Instructions for upgrading the GROCO HC or HE toilets to an HF toilet

The evolution of GROCO's HC model toilet to HE and now HF has necessitated the addition, deletion, or modification of some parts. The changes have resulted in greatly improved toilet operation.

PARTS & ASSEMBLY

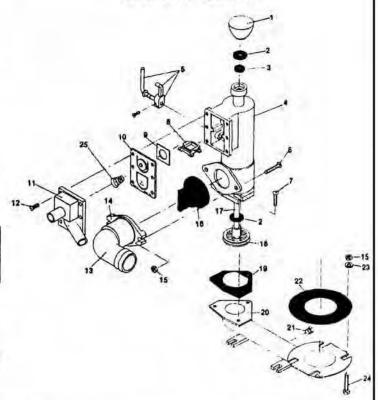
<u>Item 5</u>; <u>HF-20 Cam Assembly</u>. THe HF-20 combines the cam action required to open and close the tollet inlet with a more effective vacuum breaker, resulting in easier dry-bowl pumping and a more positive shut-off of inlet water when the valve handle is placed in 'DRY BOWL'.

<u>Item 8</u>; <u>HF-28 Bridge</u>. Provides support for Items 9 and 10, thus preventing loss of pump suction.

<u>Item 10</u>: <u>HF-1 Gasket</u>. This injection-molded part replaces former neoprene gaskets with bronze weights. It provides greater accuracy and more positive flushing with the valve handle in the 'FLUSH' position.

Items 17, 18; HF-10 Piston/Ring Assembly and HF-21 Shaft. This new design provides more positive flushing and a positive seal against back-flow from the toilet discharge. The HF-21 shaft is required in order to restrict the pump stroke length to 7-1/4".

Item 25; HF-26 Spring. Assures that the HF-1 gasket is properly seated in the 'FLUSH' position, allowing the pump to prime itself.
